DESIGN <i>[Signature]</i>	DRAWN BY <i>[Signature]</i>	DART AEROSPACE LTD HAWKESBURY, ONTARIO, CANADA	
CHECKED <i>PH</i>	APPROVED <i>[Signature]</i>	DRAWING NO. D3303	REV. B SHEET 1 OF 4
DATE 06.08.17		TITLE HEAD REST SCALE 1:3	
REV	DATE	DESCRIPTION	
A	04.08.18	NEW ISSUE	
B	06.08.17	UPDATED FLAT PATTERN TO FORM PART IN ONE OPERATION USING OFFSET DIE

D3303-041 HEAD REST

DRAWING NO. D3303	TITLE HEAD REST	REV. B	DART AEROSPACE LTD ENGINEERING ORDER		D.E.O. NO. D3303-B-1	SHEET NO. SHEET 1 OF 1	SCALE NTS
DRAWN AJS	CHECKED <i>h</i>	MFG. APPR. <i>h</i>	APPROVED <i>h</i>		DE APPR. <i>h</i>		
DATE 08.10.15	DATE <i>08.10.15</i>	DATE <i>08/10/16</i>	DATE <i>08/10/16</i>		DATE <i>08/10/16</i>

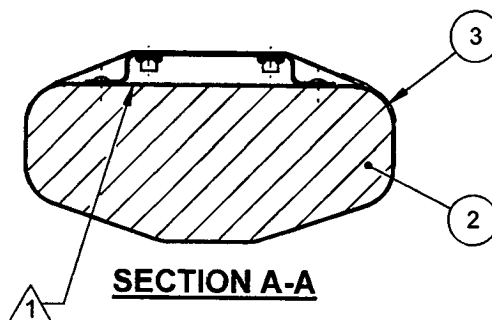
SHEET 1 ADD 1300L ADHESIVE BY 3M TO NOTE 1 AS FOLLOWS:

WAS:

- 1) BOND D3305-1 FOAM TO D3303-043 BRACKET ASSEMBLY USING 3M 1300 ADHESIVE (0.002" TO 0.010" THICK) IN ACCORDANCE WITH MANUFACTURER'S INSTRUCTIONS

IS:

- 1) BOND D3305-1 FOAM TO D3303-043 BRACKET ASSEMBLY USING 3M 1300 OR 1300L ADHESIVE (0.002" TO 0.010" THICK) IN ACCORDANCE WITH MANUFACTURER'S INSTRUCTIONS
